Arlington Historic District Commissions

Property: 0 Ravine Street

Proposed 0 Ravine Street infill inconsistent with Historic District Guidelines

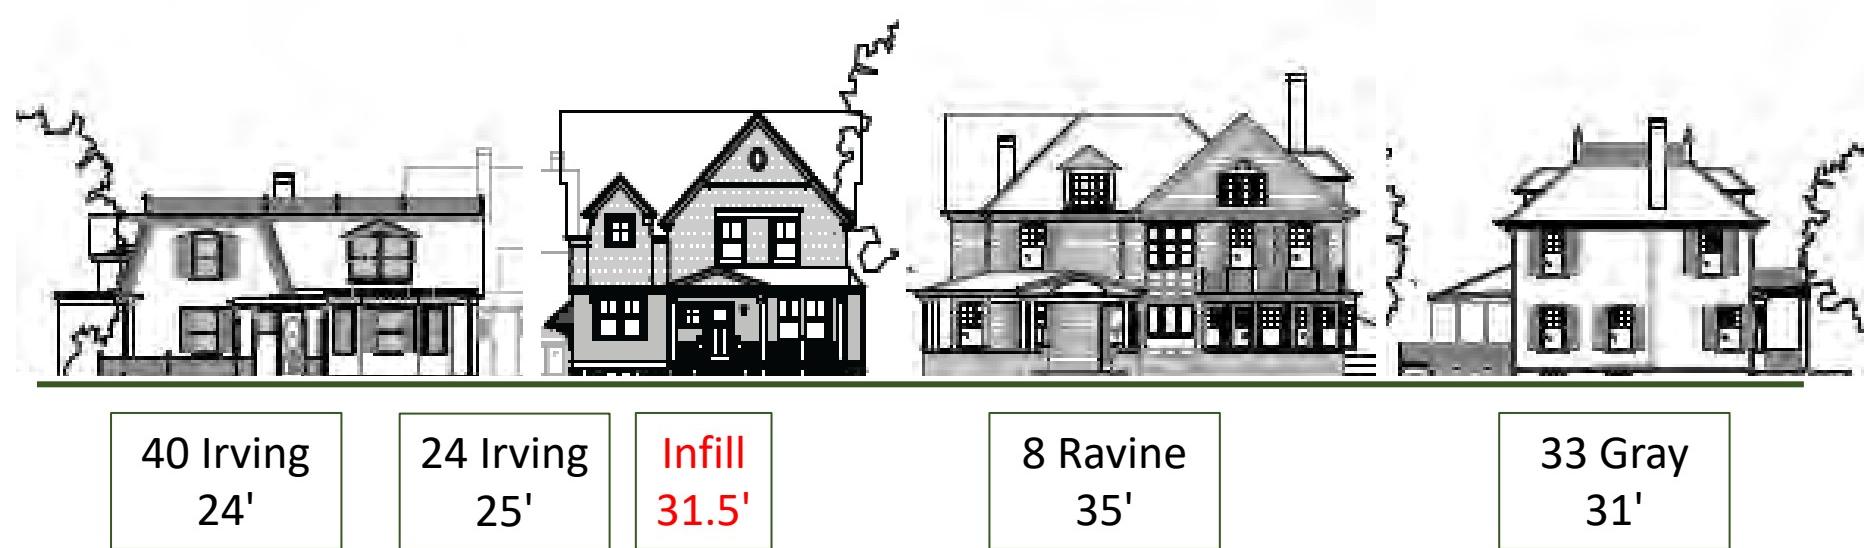
Too tall

- The infill will tower over its neighbors
- At 31.5 feet tall, the infill will be...
 - 7 $\frac{1}{2}$ feet (nearly a story) taller than its immediate neighbor at 40 Irving
 - 6 $\frac{1}{2}$ feet taller than its neighbor to the back at 24 Irving
 - $\frac{1}{2}$ feet taller than its neighbor up the street at 33 Gray
 - Just 3 $\frac{1}{2}$ feet shorter than its neighbor to the left at 8 Ravine
- All on a smaller lot, with a very differently “square” house

Building envelope: width, height, aspect ratio

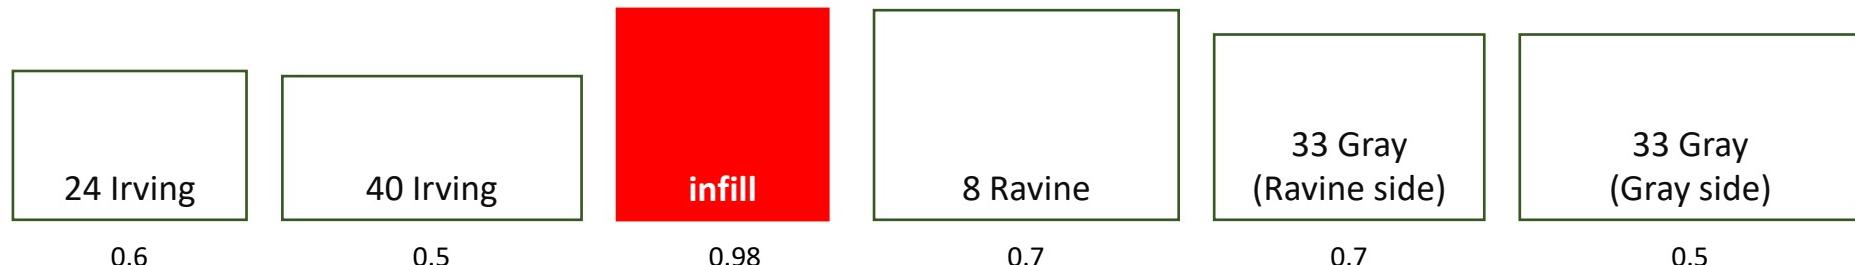
- The infill will appear as an **ungainly square tall and narrow house squeezed into a small lot**
- A nearly square height to width ratio (0.98) significant outlier compared to neighbors (average: 0.6 average; minimum: 0.5; maximum: 0.7)
- Infill is **not really a shingle style house**; shingle style architecture is characterized by “a sense of the house as continuous volume”, with its emphasis on **horizontal continuity** – the only thing that makes this tall, thin infill “shingle style” is the shingles
- To be harmonious with the other homes, at proposed width, the **maximum height should be less than 19 feet** ($31 \text{ feet wide} \times 0.6 = 18.6 \text{ feet}$)

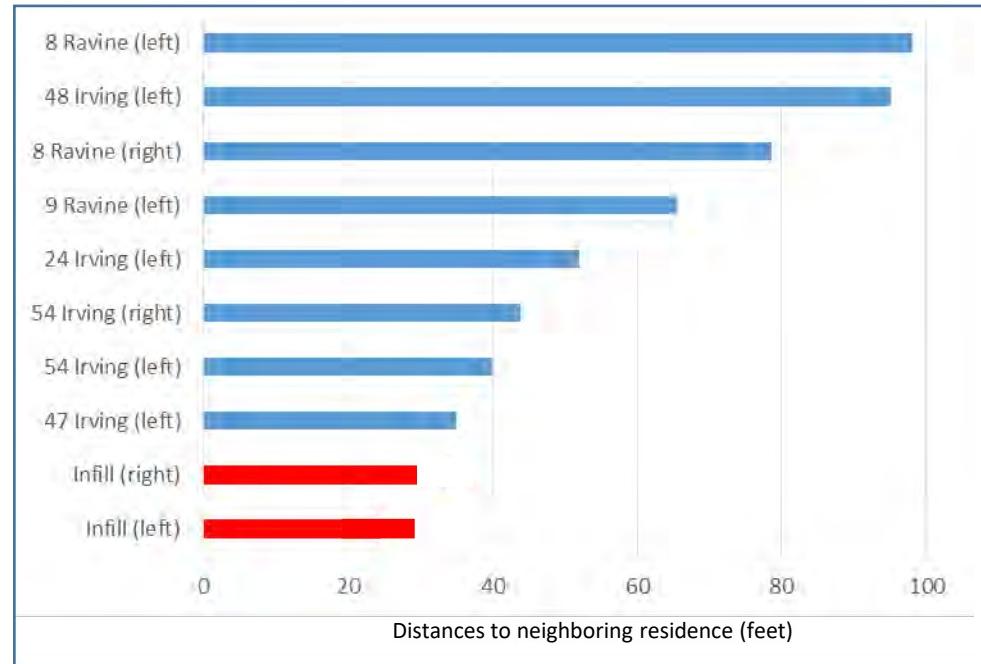
- **Average** side spacing between residences for relevant properties is 67' on each side
- Minimum spacing is 35' (for 47 Irving which has nearly 100' to the street side)
- Proposed **infill is shoehorned** in with 31 ½' on one side and 31' on the other – **less than half** of the surrounding residences' average

- To be harmonious with surrounding residences suggest spacing at least the neighborhood minimum of 35' both sides

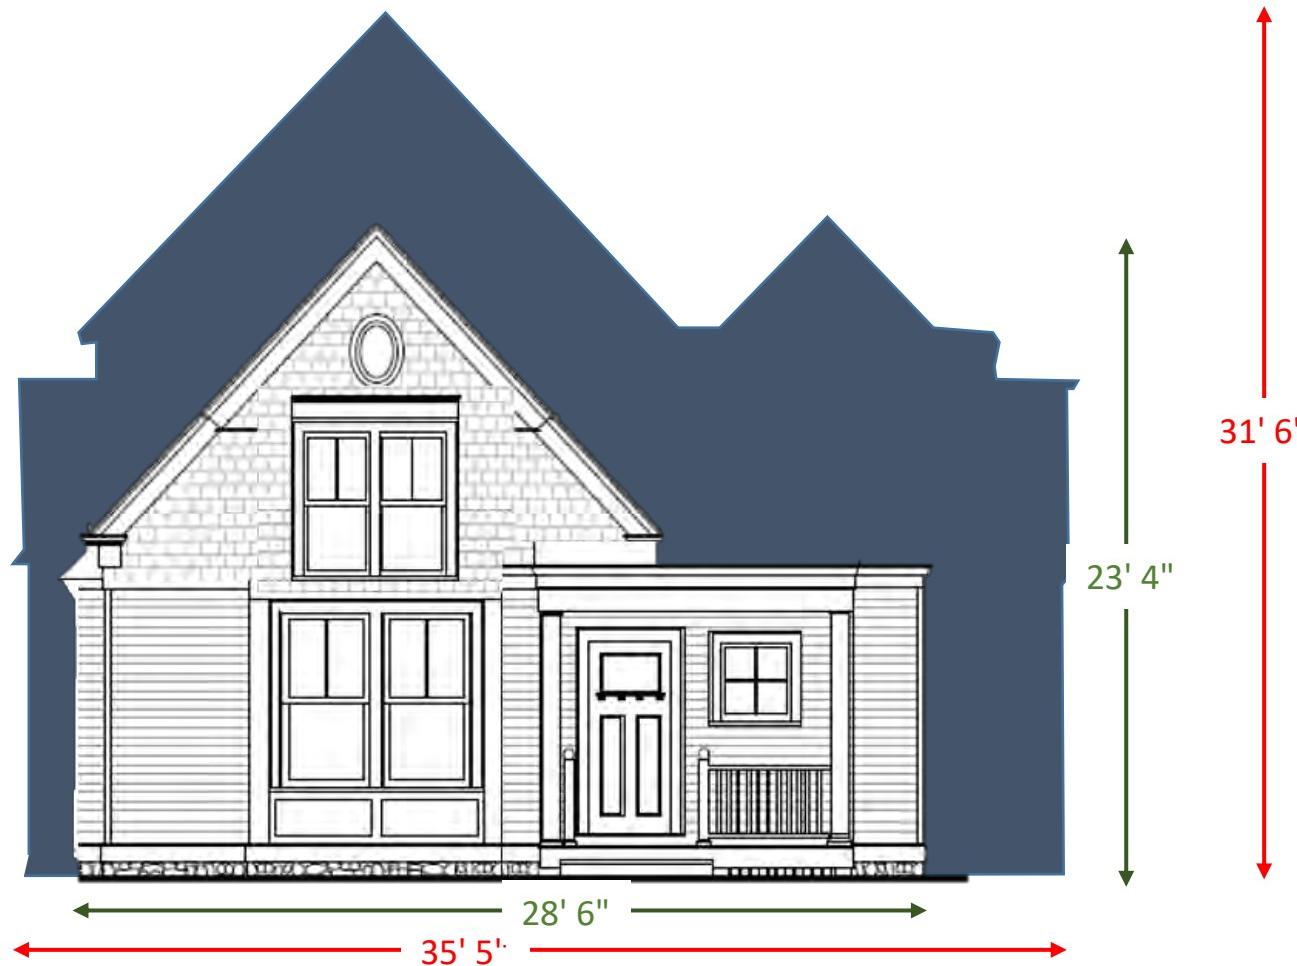
- Applicant’s drawing shows view of 24 Irving/historic barn replaced with view of parking pad

Infill front elevation: proposed versus appropriate

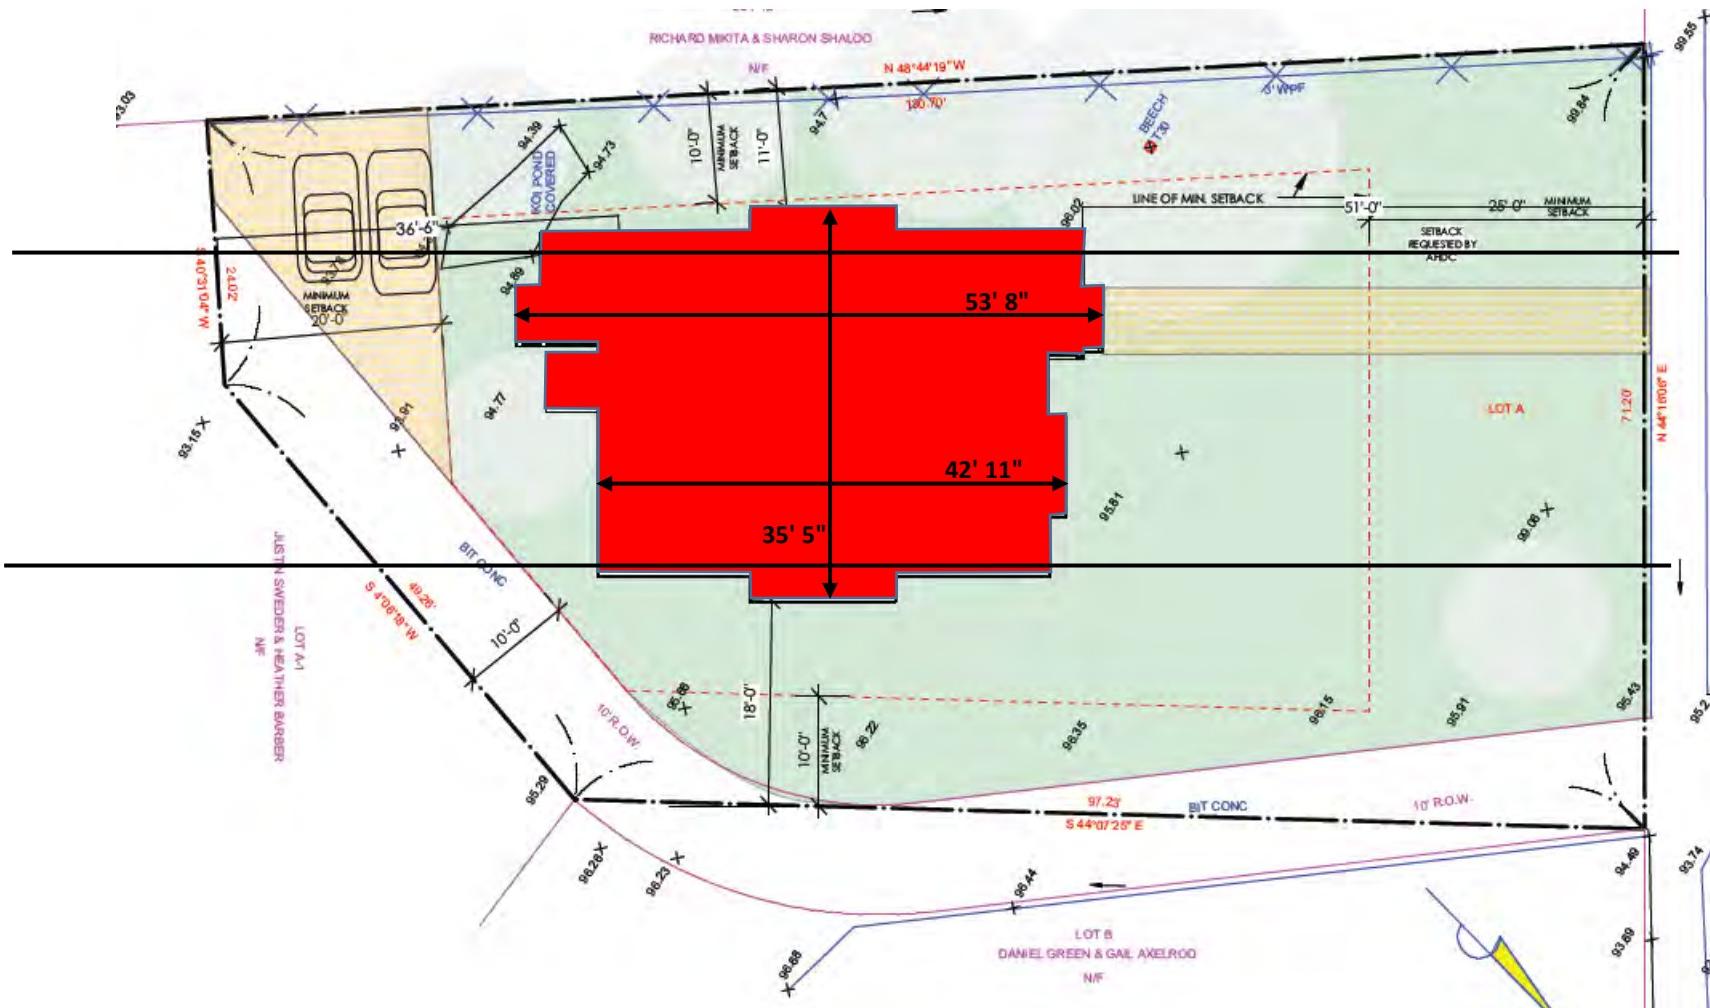
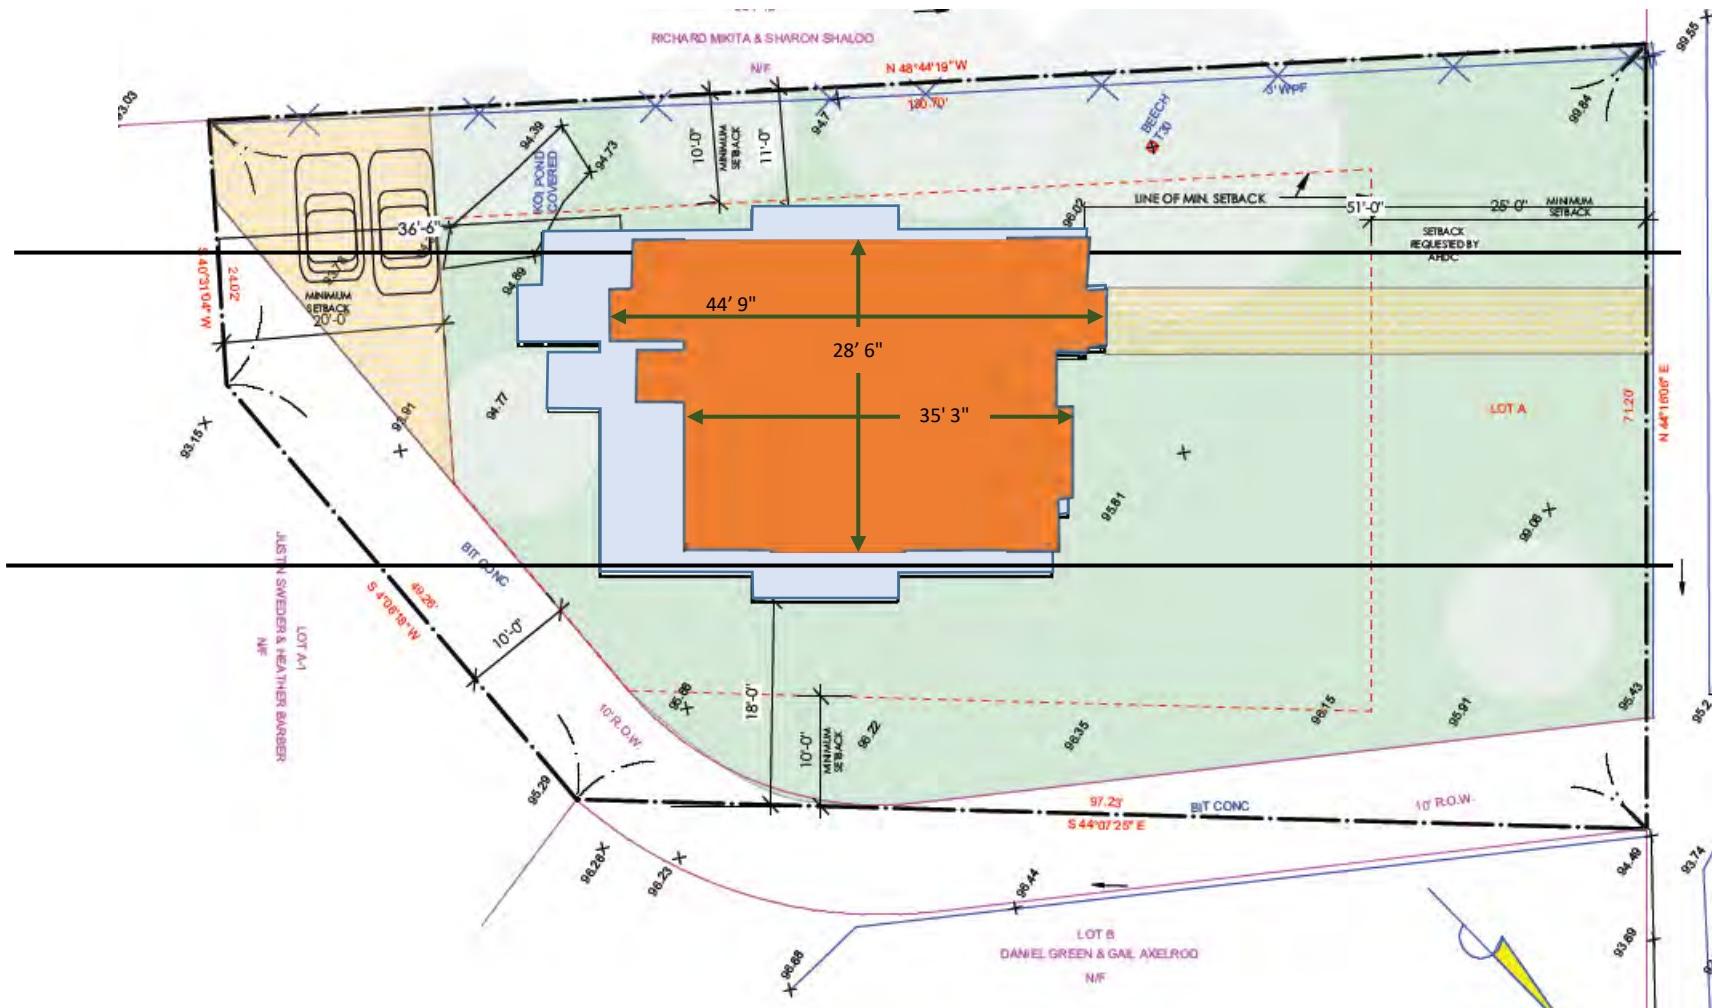
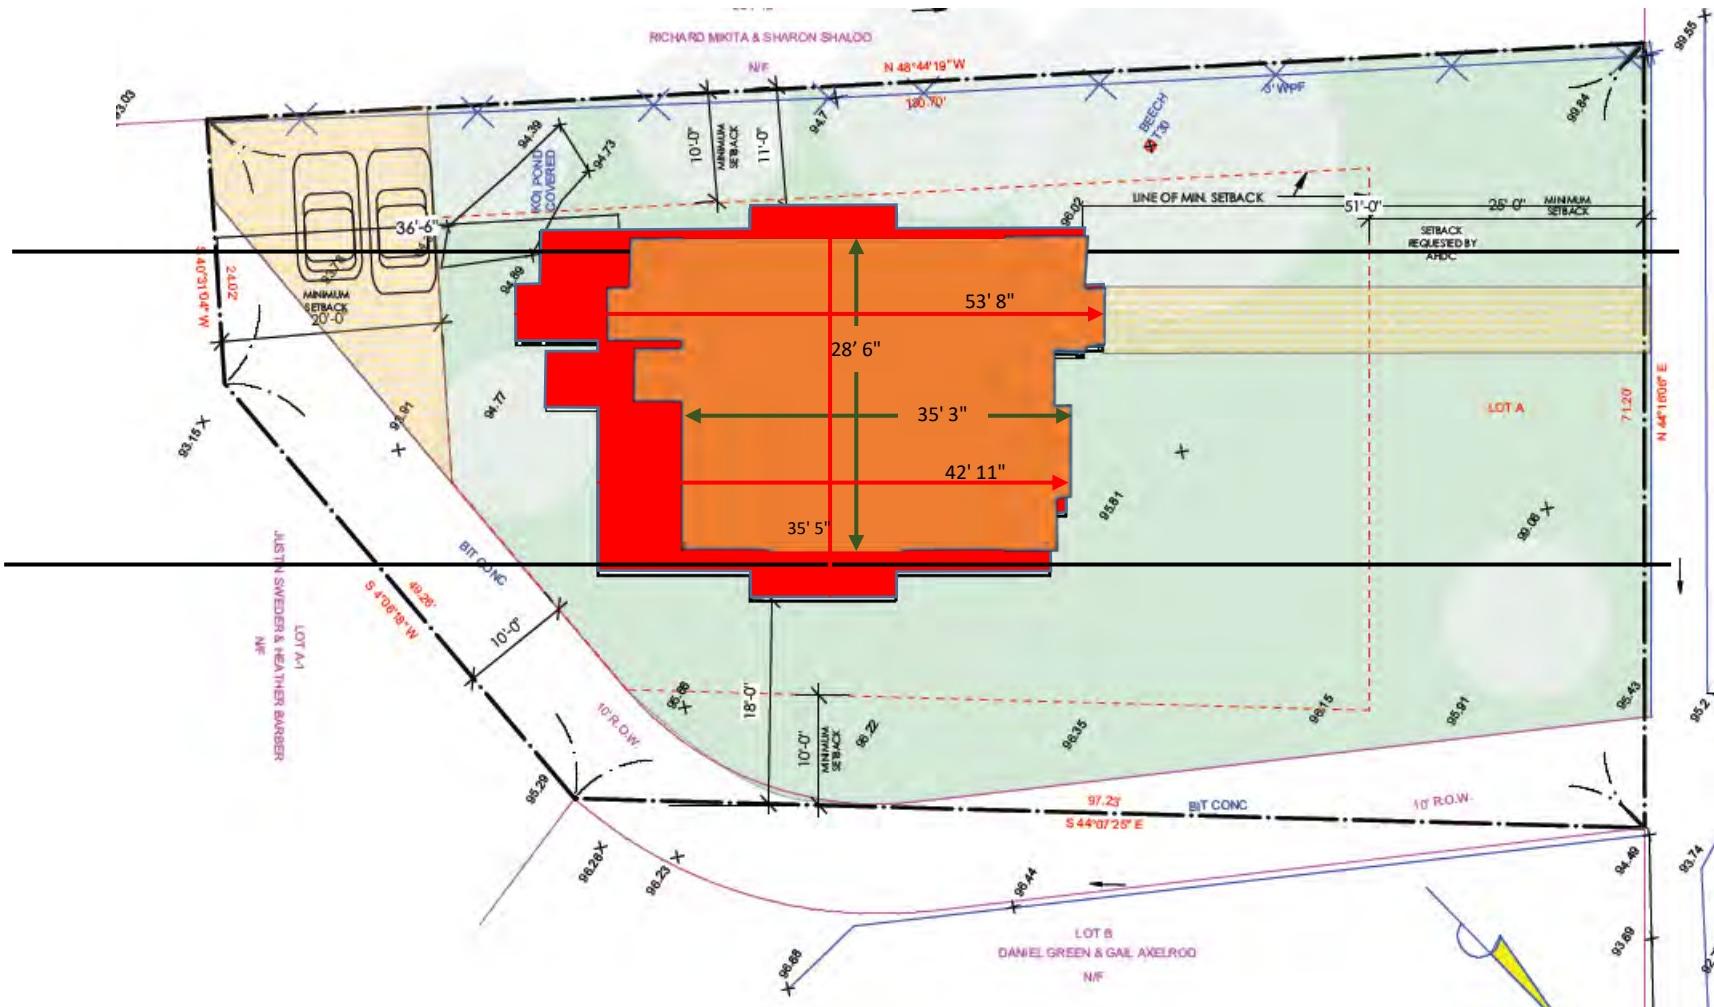
Proposed infill footprint: 53' 8" x 35' 5"

Appropriate footprint: 44' 9" x 28' 6"
